MANUAL CHANGES

MANUAL IDENTIFICATION

Model Number: 141T
 Date Printed: June 1976
 Part Number: 00141-90914

Figure 2.
Low Voltage Schematic
8

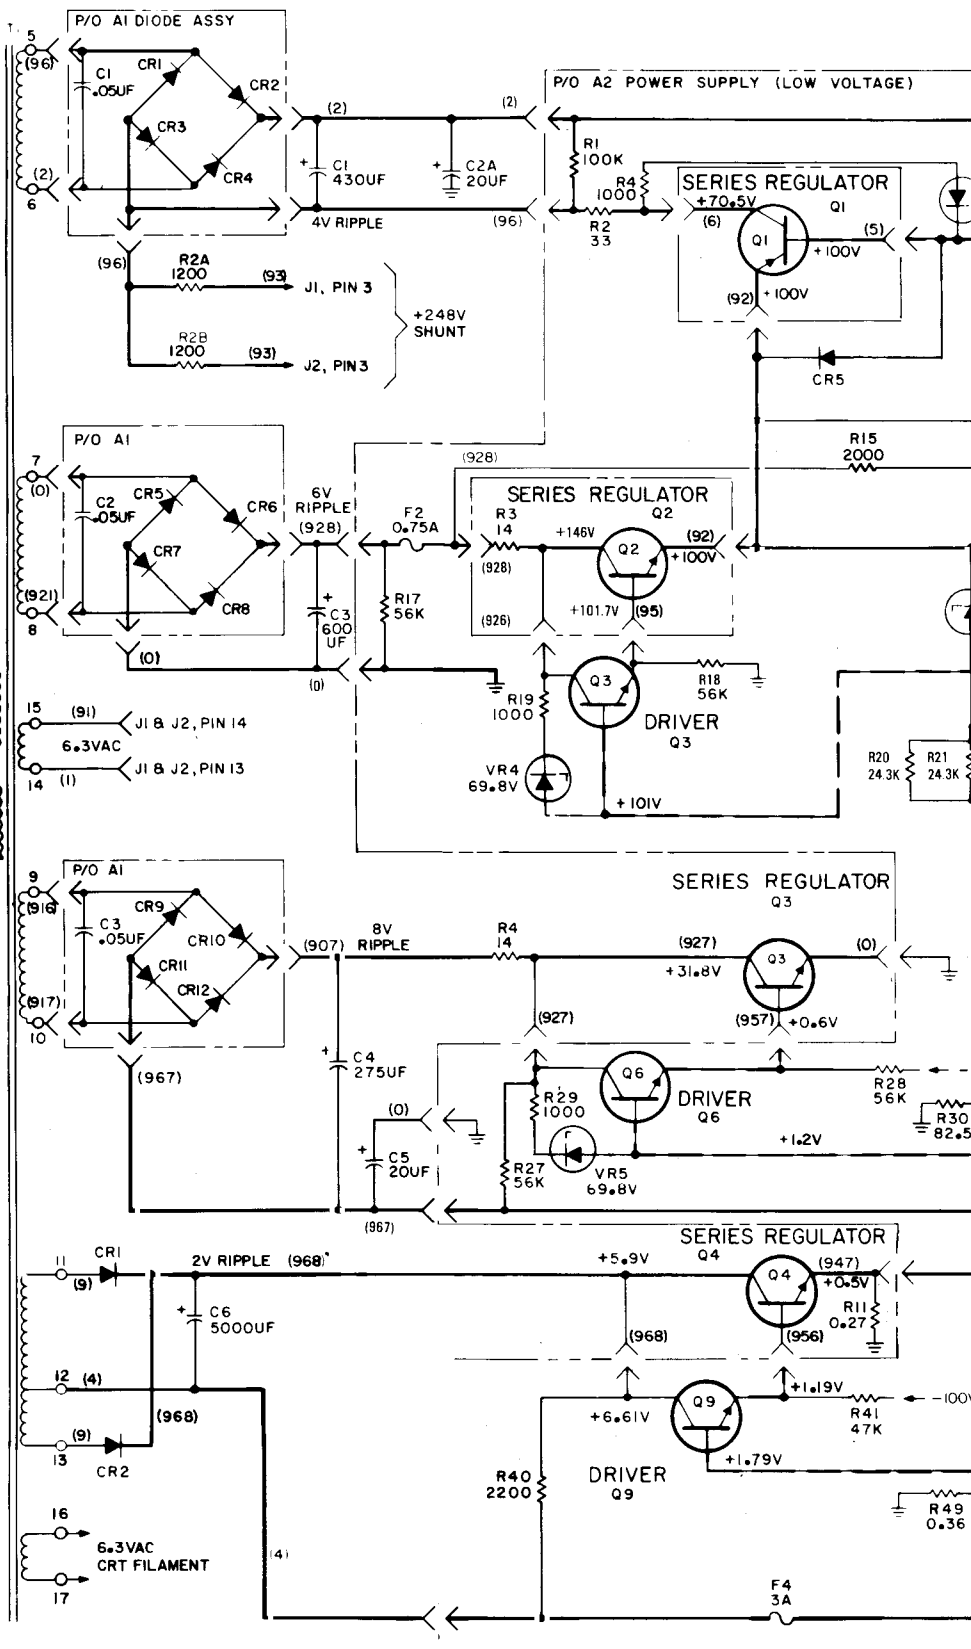
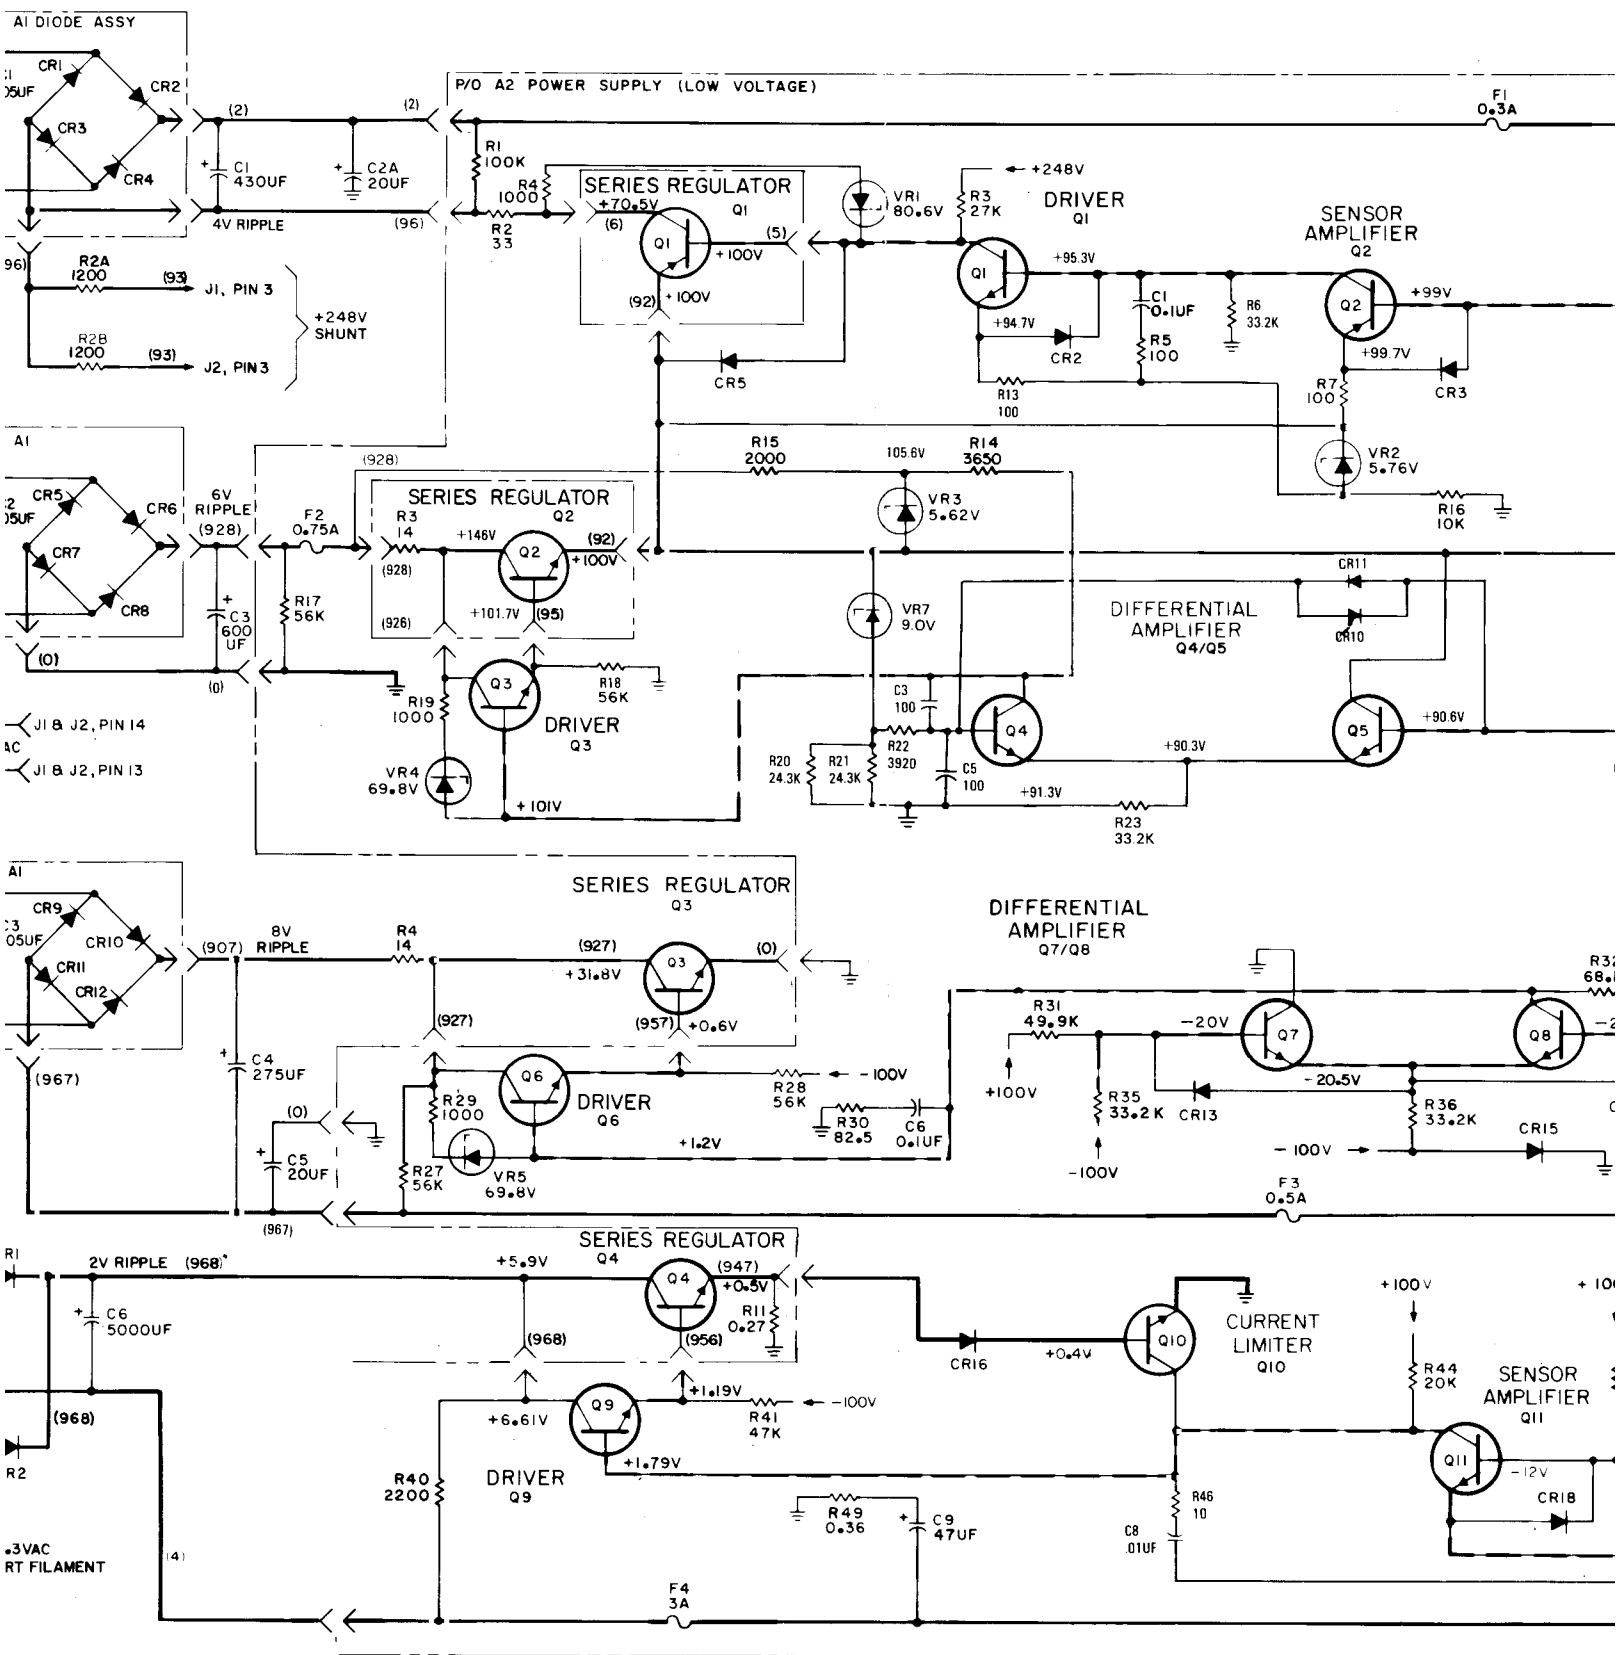
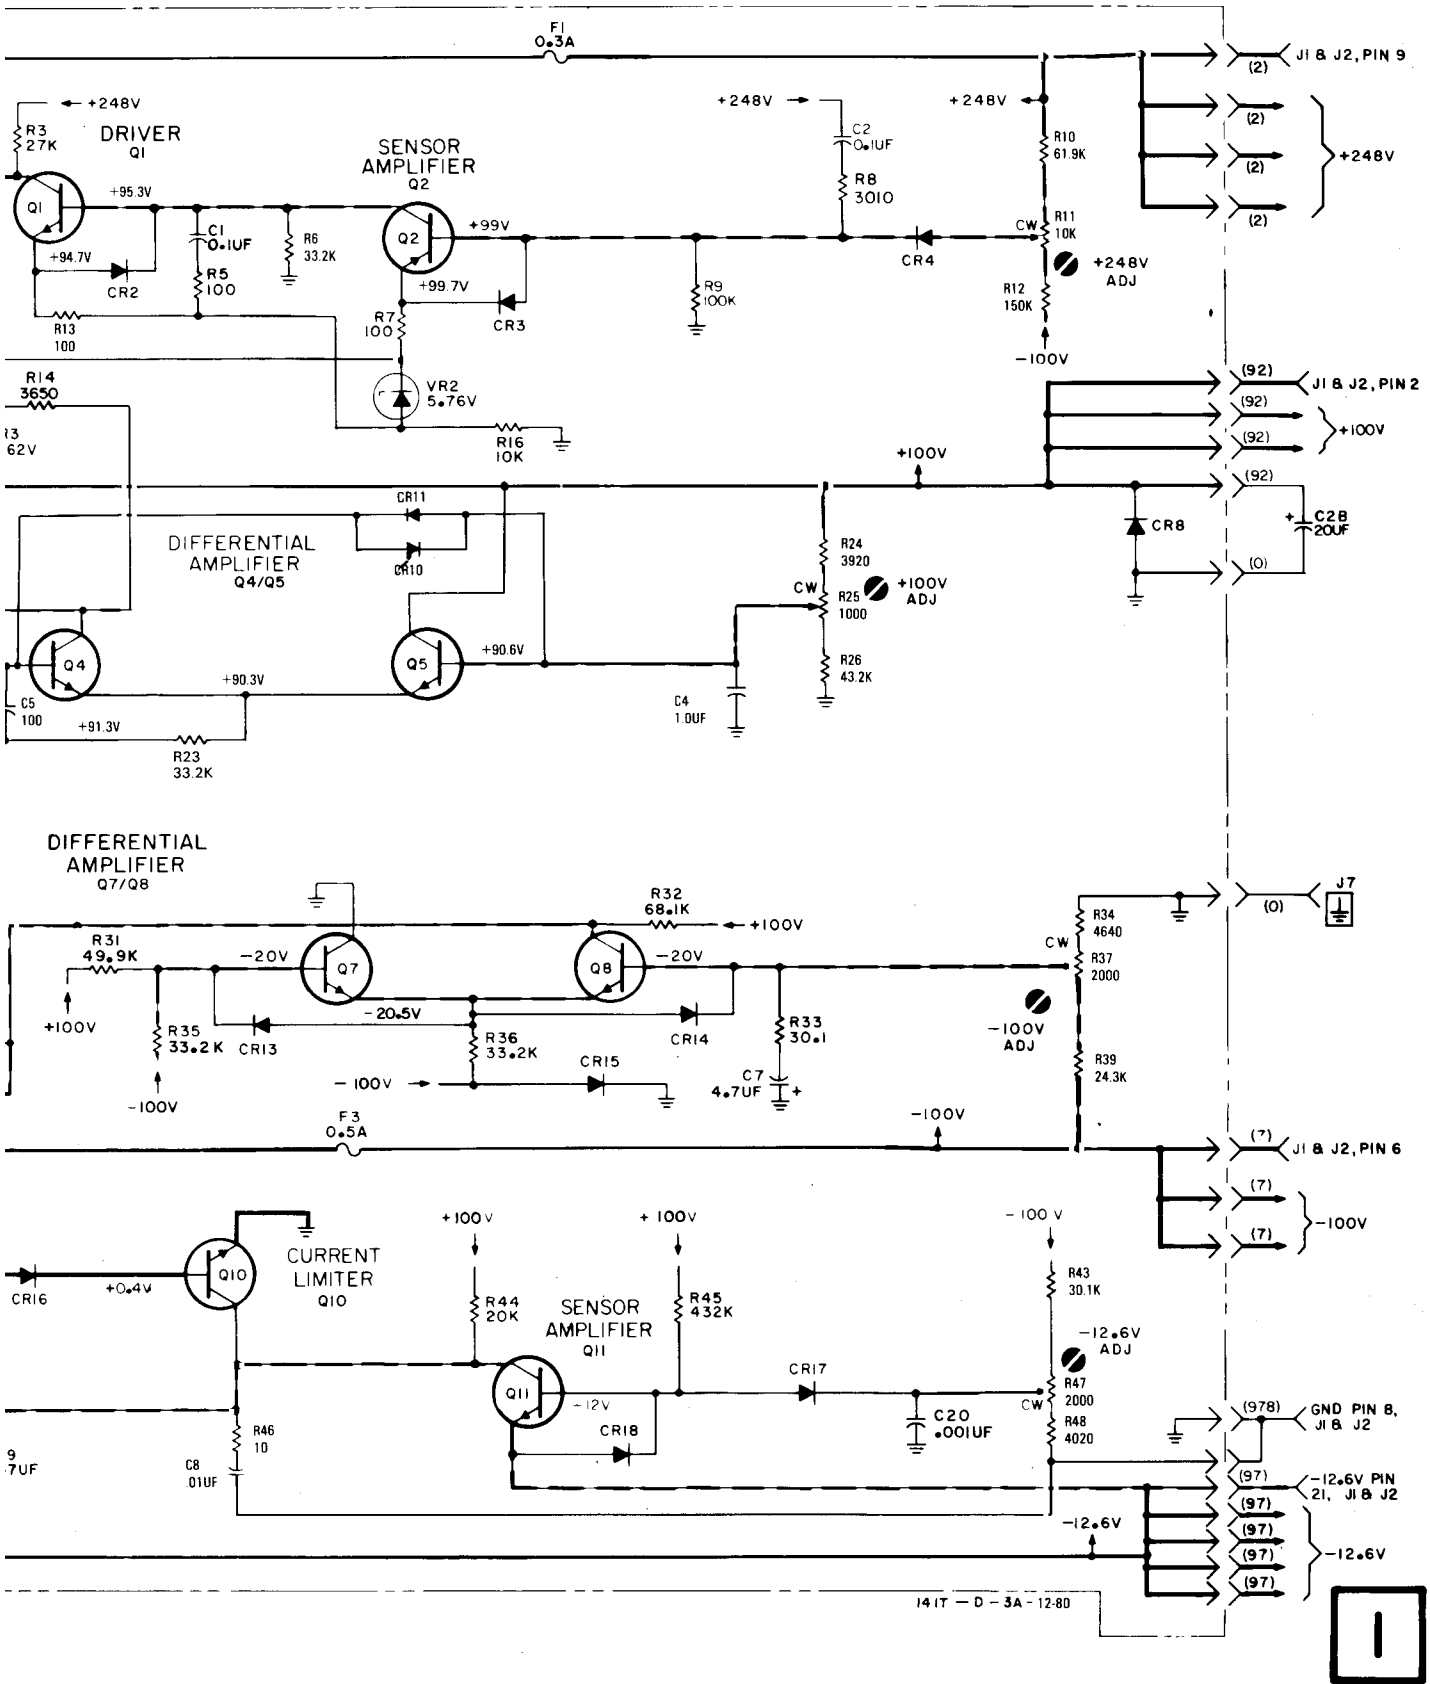
Figure 8-10. Low Voltage Schematic (page 8-15),

Replace with Figure 2 of this document.
